Minutes of the pre-bid meeting held on 21.08.2020

Ref: Tender Enquiry No. CPU/52/0720/9953 dated 28.07.2020

IMD has invited tenders from Indian bidders in Indian currency INR only, for procurement of Automated Weather Observing Systems (AWOS) at 18 Airports. The competent authority has constituted the Pre-Bid Committee to provide clarification on various tender provisions/clauses, comprising of following members:

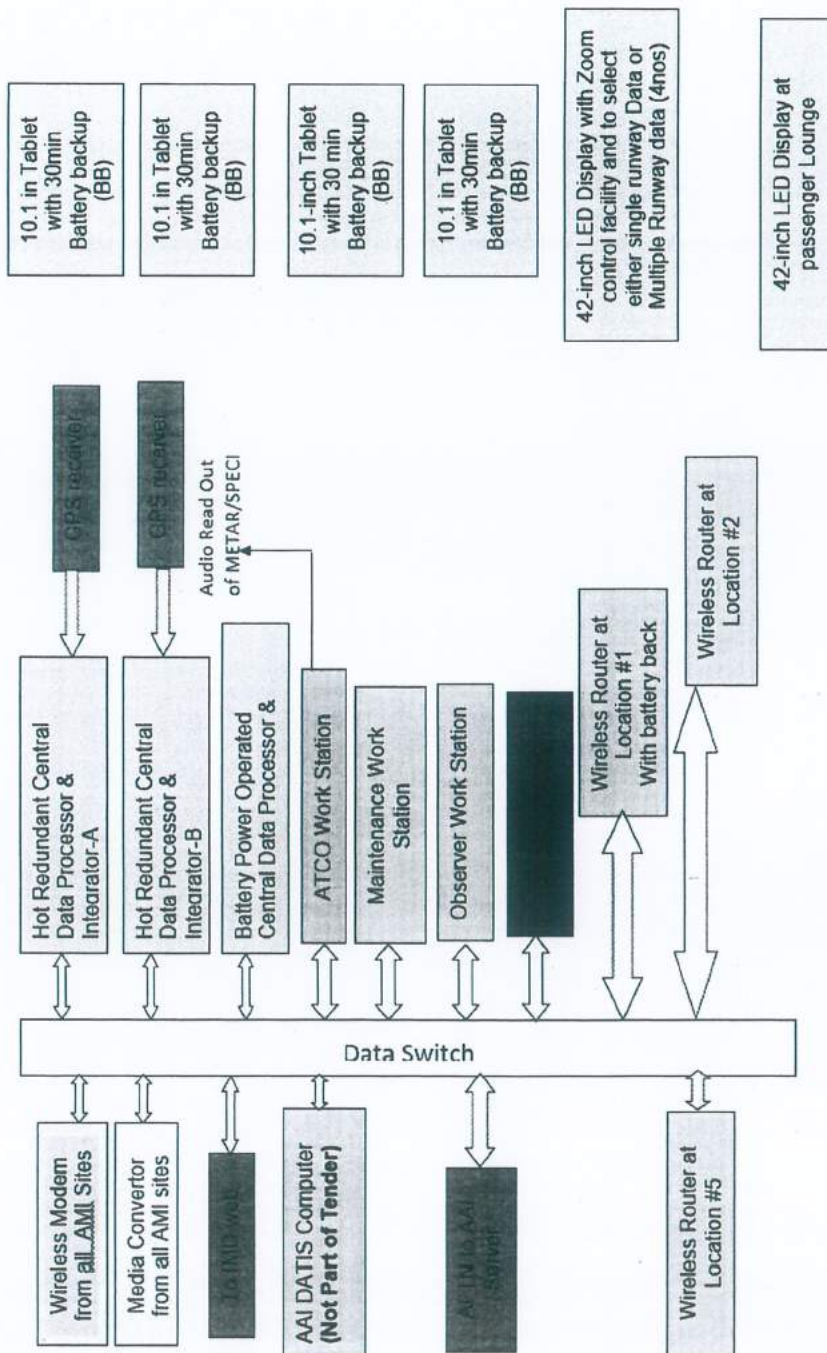
3.3			We request IMD to provide the Annexure 1 again since we cannot read the block diagrams properly. Especially the indoor unit details.	Layout of Indoor Equipment is attached at Annexure-1.

7.68	62	Annexure I, N/A	Please provide an updated image. The image provided in the tender is cutoff at the bottom.	Layout of Indoor Equipment is attached at Annexure-1
